VERIFICATION TESTING AND ANALYSES
OF THE 17 x 17 OPTIMIZED FUEL
ASSEMBLY

APPROVED VERSION: AUGUST 1981

SUBJECT: ACCEPTANCE FOR REFERENCING TOPICAL REPORT WCAP 9401(P)/WCAP 9402(NP)

Figure 3-12 412 17x17 8-Grid Optimized Fuel Assembly Normalized Vibrational Modal Shapes

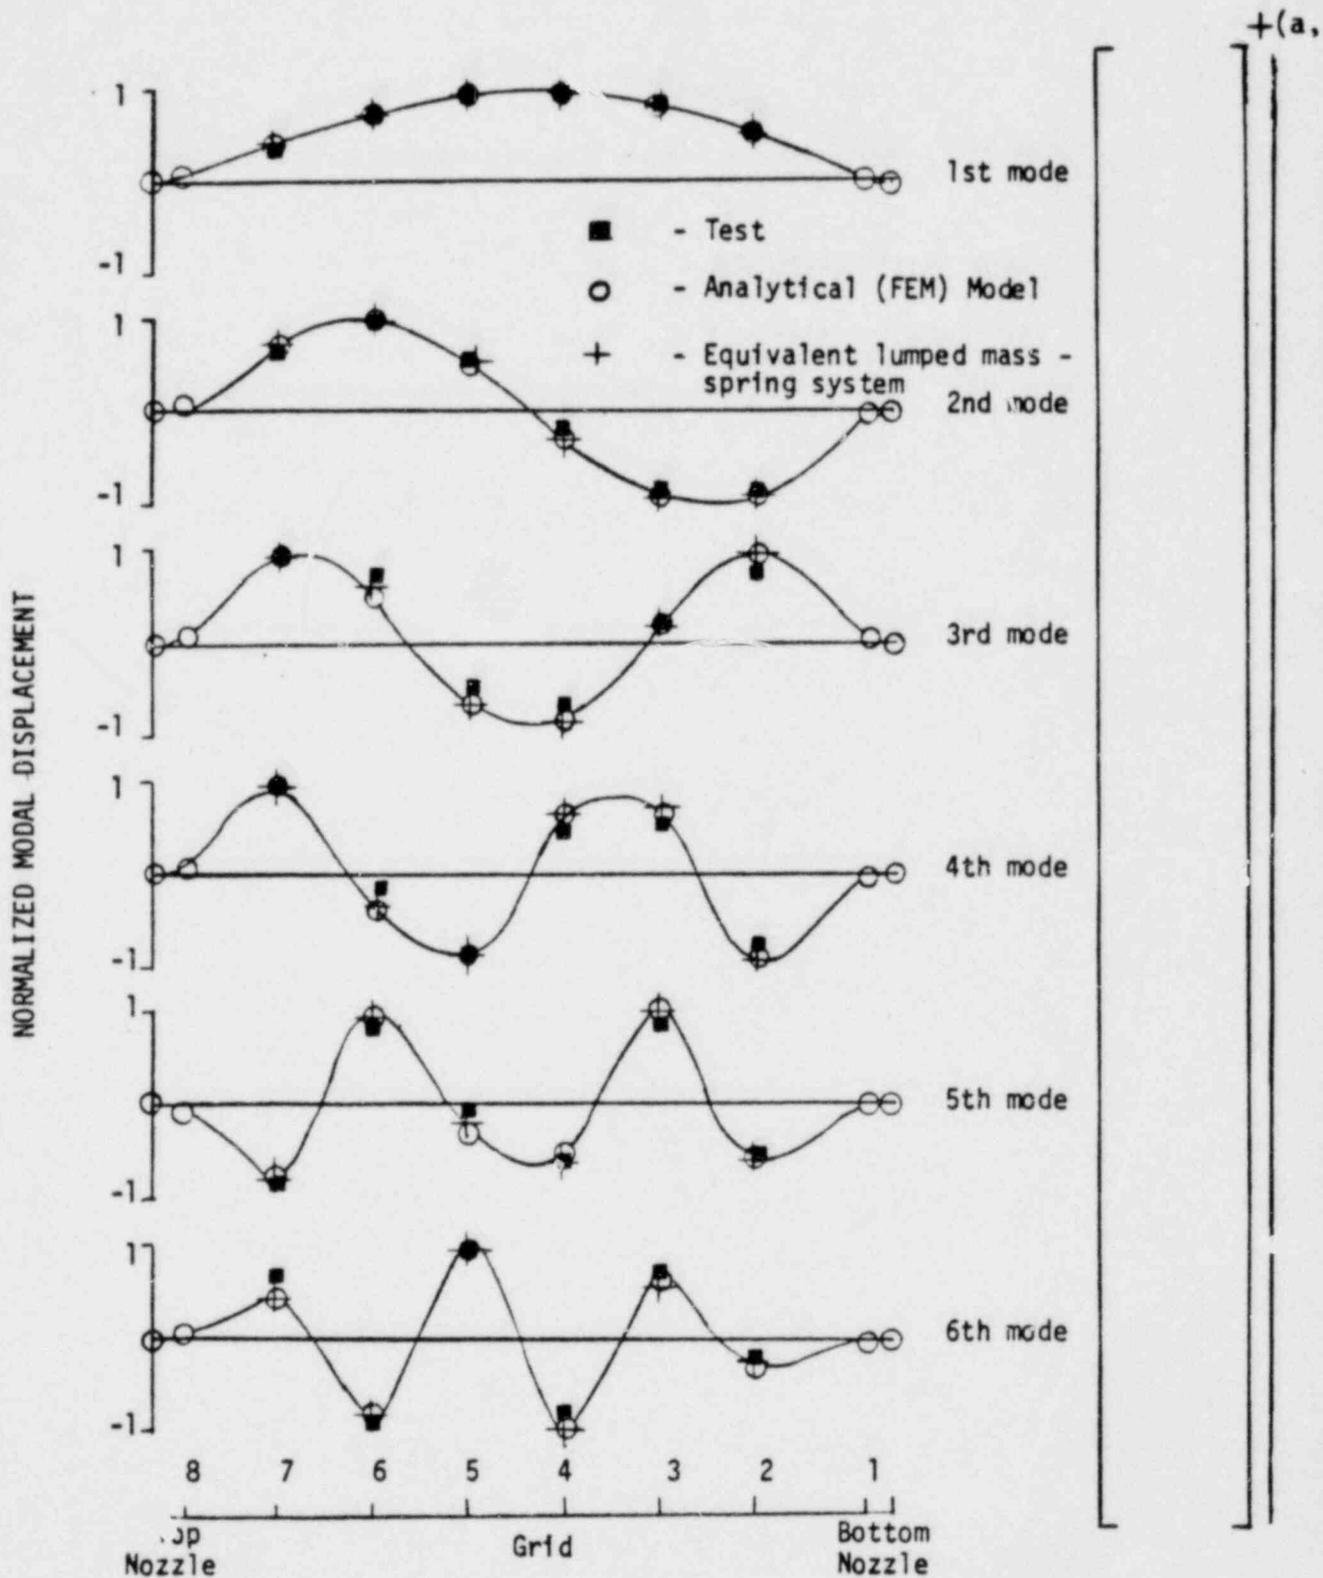
Are the analytical predictions presented in Figure 3-12 derived from the model values presented in Table 3-1? If not, discuss the differences.
